ANNEXURE C

Mosquito Risk Assessment
Proposed Residential Development
Lot 2 DP 1119830
Alexandra Drive
Bellwood

Supplementary Engineering Information by De Groot Benson Pty Ltd

**DEVELOPMENT APPLICATION NO, 2012/011, 346 LOT RESIDENTIAL
SUBDIVISION PLUS RESIDUE AND ASSOCIATED WORKS - STAGED,
LOT: 2 DP: 1119830 ALEXANDRA DRIVE, NAMBUCCA HEADS
Supplementary Engineering Information**

Drawing No.
C101

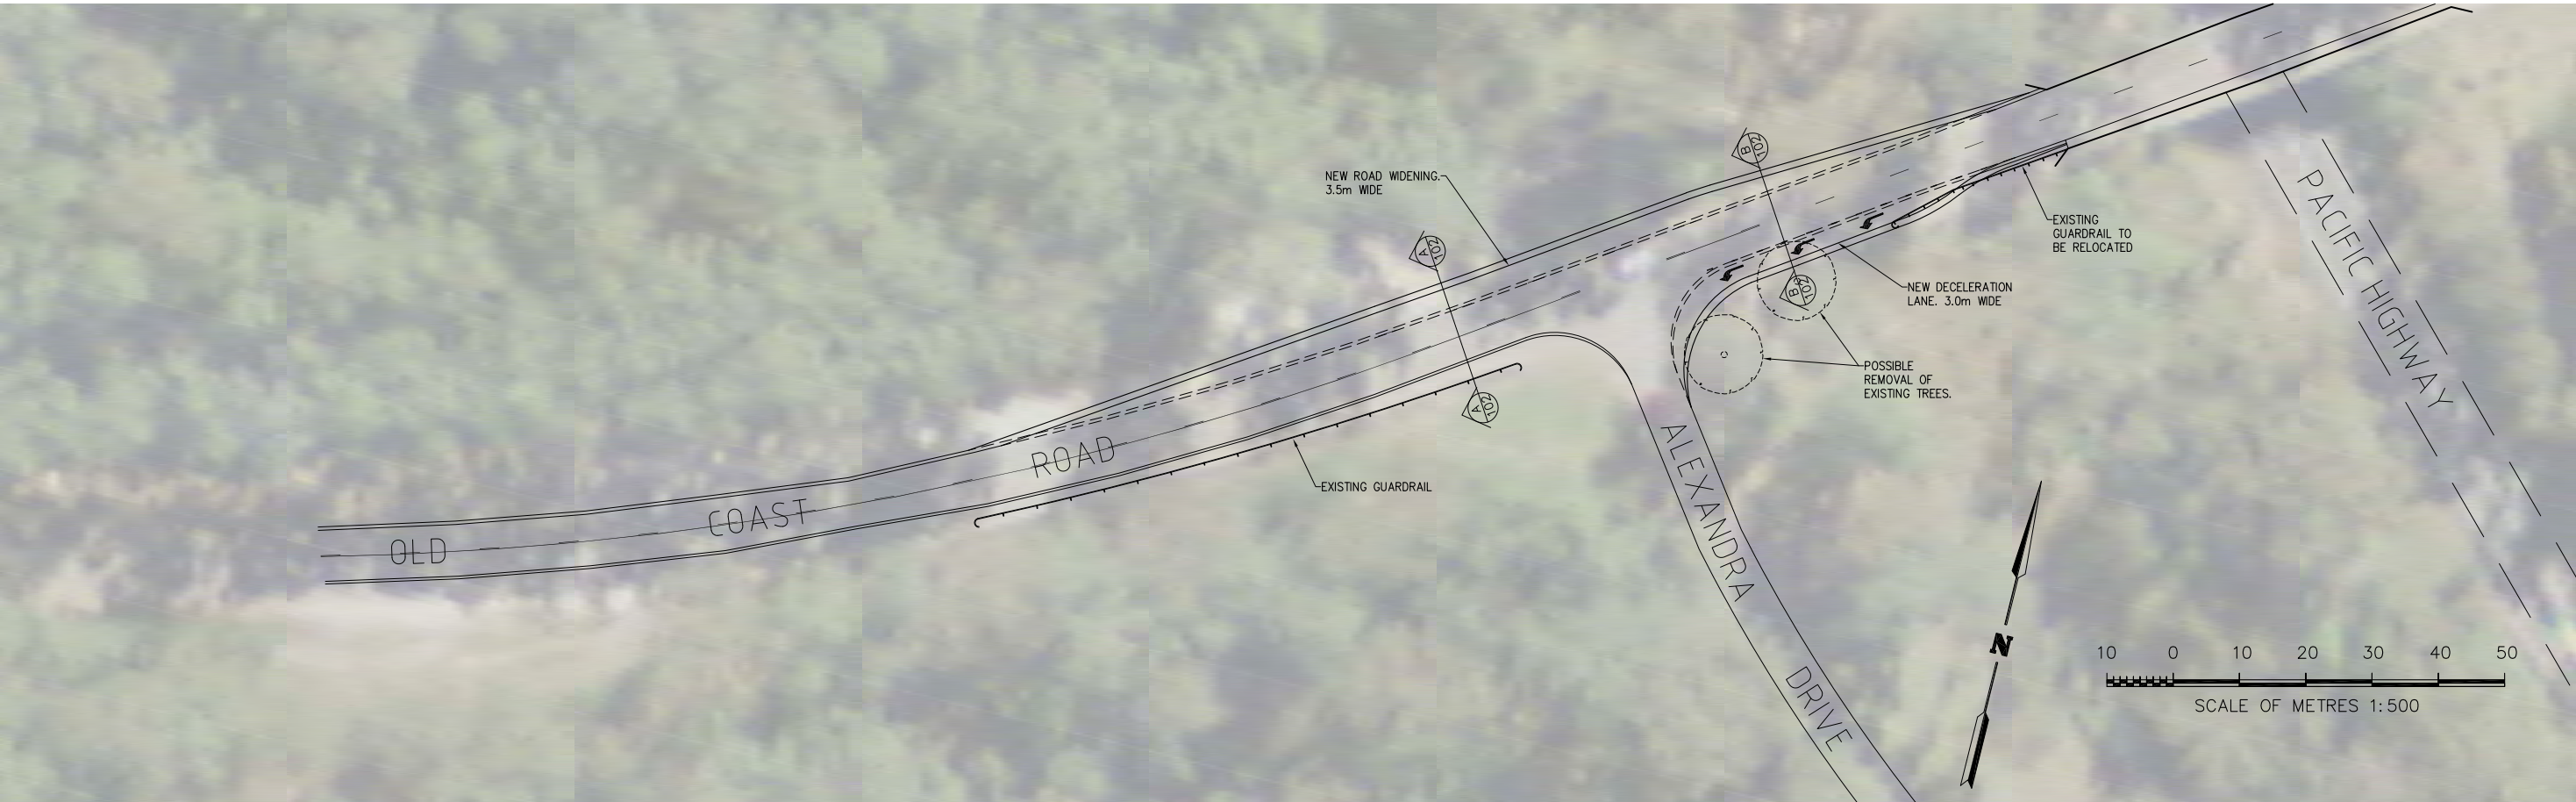
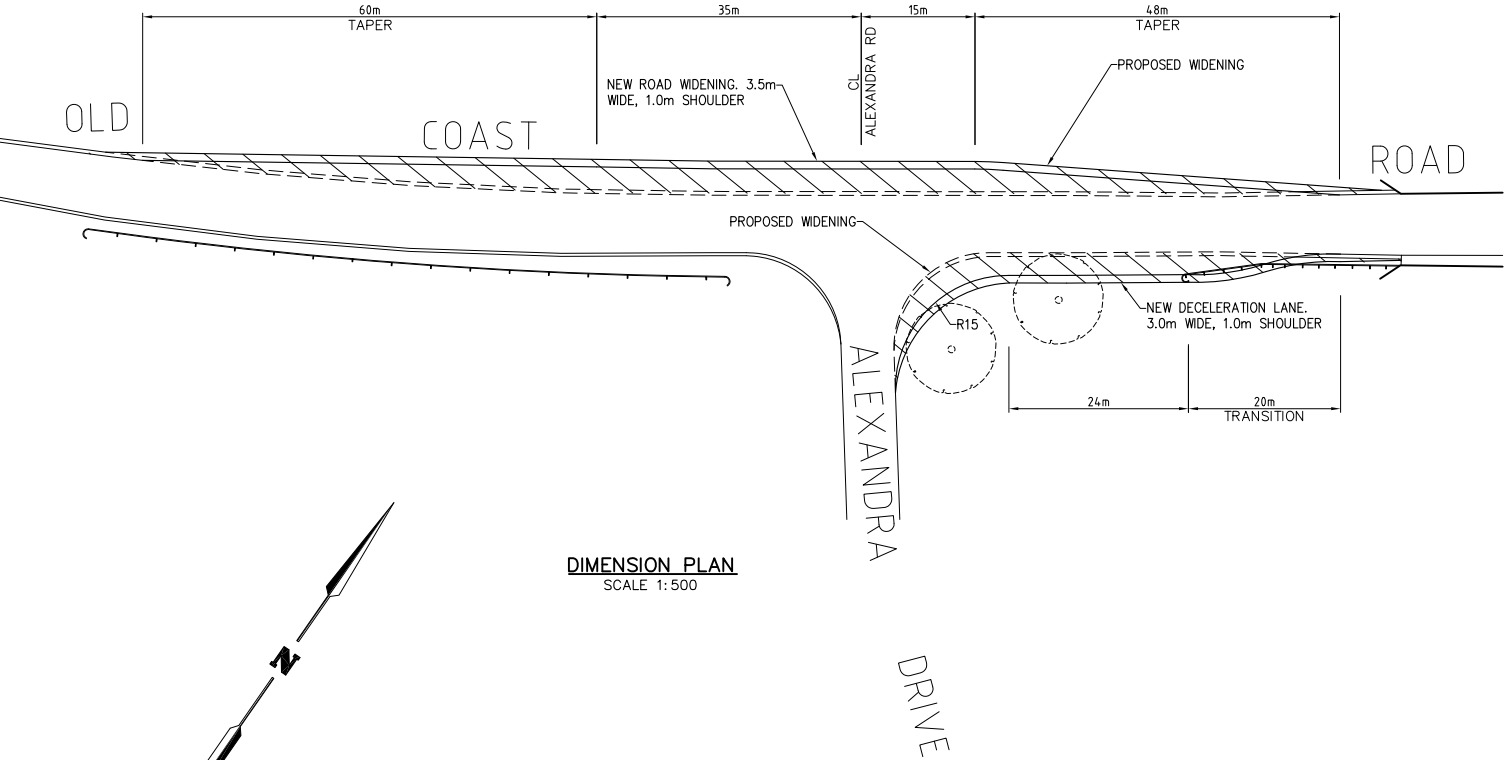
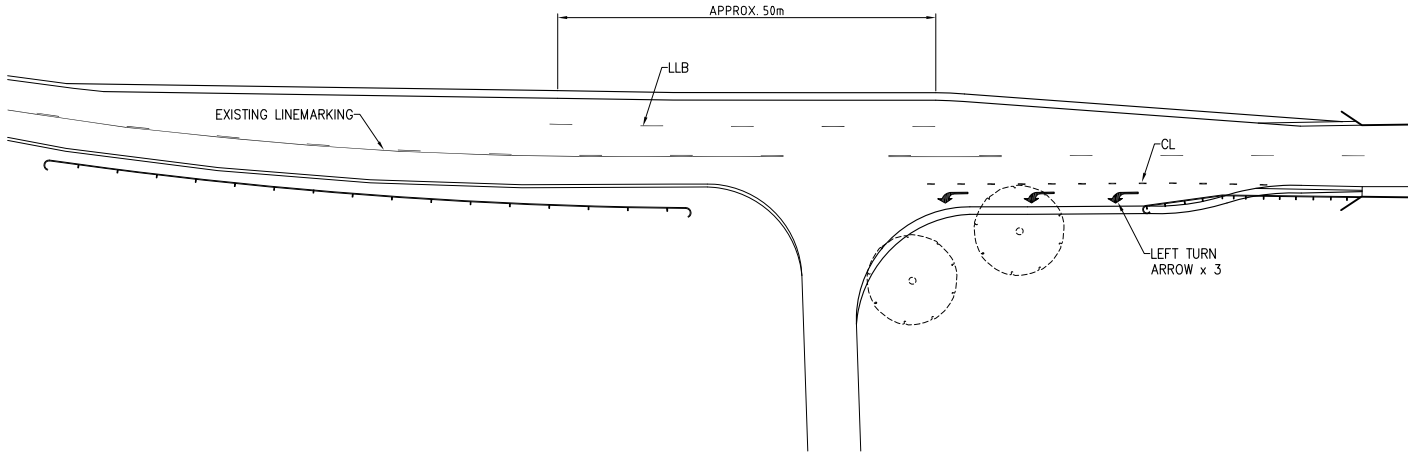
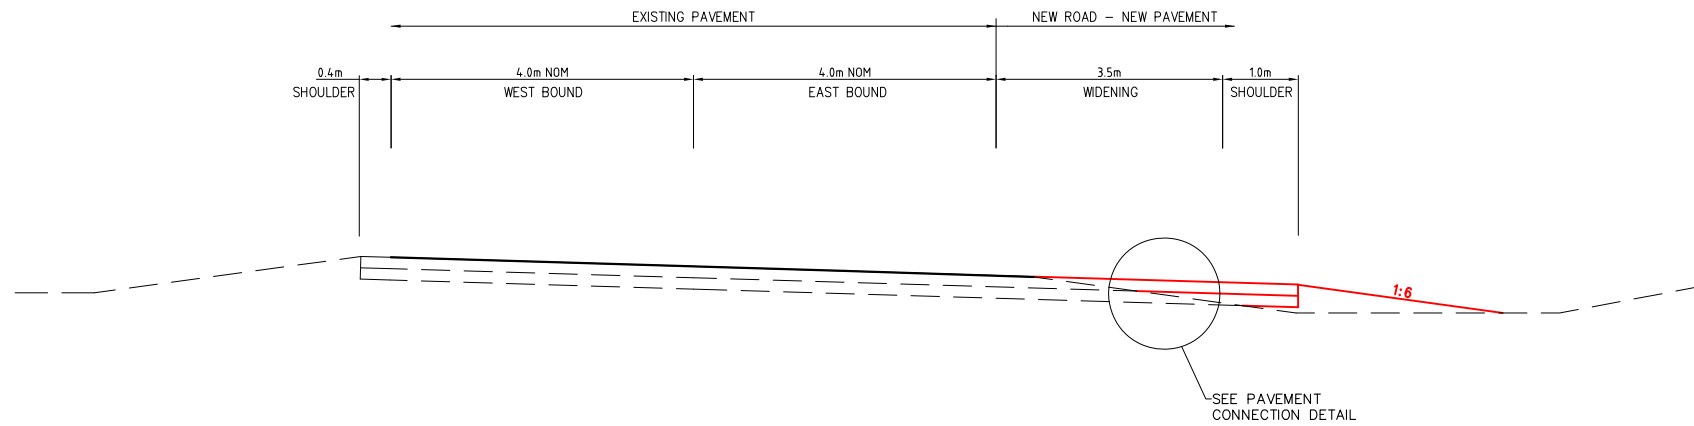
d) . Recommended traffic calming and pedestrian link options along Marshall Way and Alexandra Drive	See comments above
e) . Design details for the required roundabout at the intersection of Old Coast Road and Alexandra Drive, this intersection upgrade being needed as a consequence of the proposed development.	The traffic Assessment did not propose a roundabout at the intersection of Old Coast Road and Alexandra Drive, rather a simple T intersection. Attached is drawing 91111-C101 and C102 which show a suggested layout plan of the intersection,
